# Electronic Design

**Module:** SGEE6000 – Electronic Design

**Assignment:** Regulated Power Supplies

## GRADEMARK REPORT

Figure 1- part of psu to design

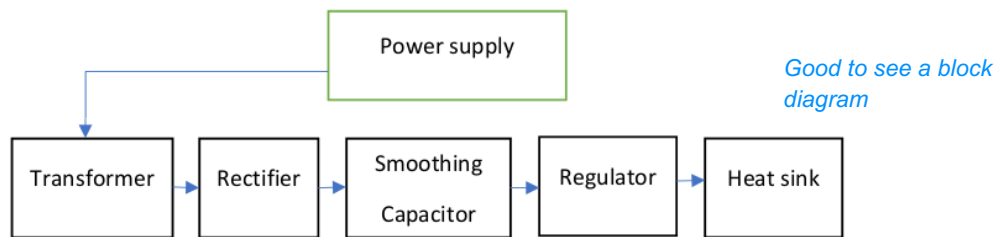
**Text Comment.** Good to see a block diagram

Figure 4- Schade graph 1

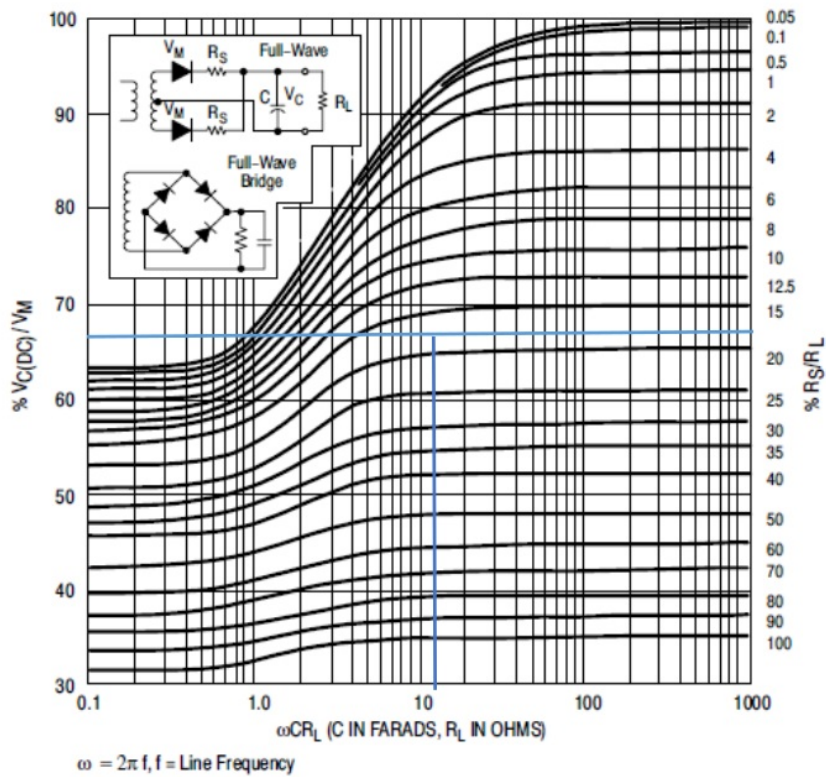
*Seems a little low, would expect 2000uf at least*
